McCULLOCH SERVICE BULLETIN

NO. 1719

MODEL: MAC 60, 70, 80, 95 DATE: December 15, 1981

SUBJECT: STRING TRIMMER (12-)

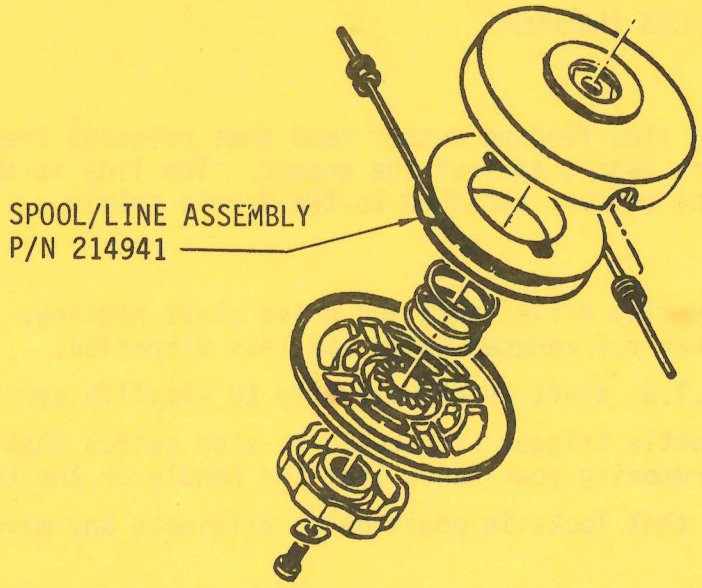
3. Spool/Line Assembly, P/N 214941, is now available for the MAC 95 String Trimmer at a manufacturer's suggested list price of $2.25. This assembly is included in Cutter Head Assembly, P/N 95878, (See Illustration). Please note this in your copy of Illustrated Parts List, P/N 214935.
